Office Action Summary	Application No. 10/698,756	Applicant(s) SHIBATA ET AL.	
	Examiner Monique M. Wills	Art Unit 1745

DETAILED ACTION

Figure 1

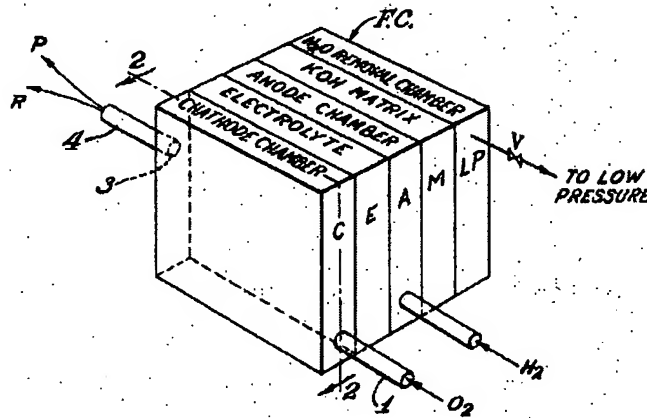
Claims 12-15 are rejected under 35 U.S.C. 102(b) as being anticipated by Gidaspow et al. U.S. Patent 3,823,038.

With respect to **claim 13**, the electrode is an anode or a cathode. See Figure 1. With respect to **claims 14-15**, the metal is stainless steel (col. 9, lines 20-30). Therefore, the instant claims are anticipated by Gidaspow.

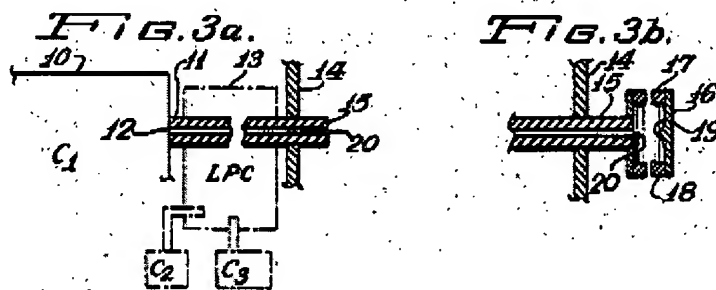
With respect to **claims 20, 23 & 28**, the needle is adapted to a housing with a first chamber that contains fuel, and second chamber adapted to receive gaseous fuel, the second chamber by a chamber-separating septum adapted to received the needle. See Figures 3a and 3b.

With respect to **claim 24**, the fuel cell is connected to a load. Figure 3c. With respect to **claims 25-26**, the metal is stainless steel (col. 9, lines

20-30). With respect to **claims 21 & 36**, the needle enters a fuel cartridge, wherein the first chamber has a inlet pore leading to needle 2. See Figure 1. An inlet pore of the hollow members is received within the second chamber [19]. See figure 36. With respect to **claim 29**, the fuel is hydrogen fuel (col. 4, lines 5-10). With respect to **claims 33 & 34**, the chamber 19 is partially porous and the chamber 19 covers the end of needle [15] guiding hydrogen gas into the fuel cell. See Figure 3b.
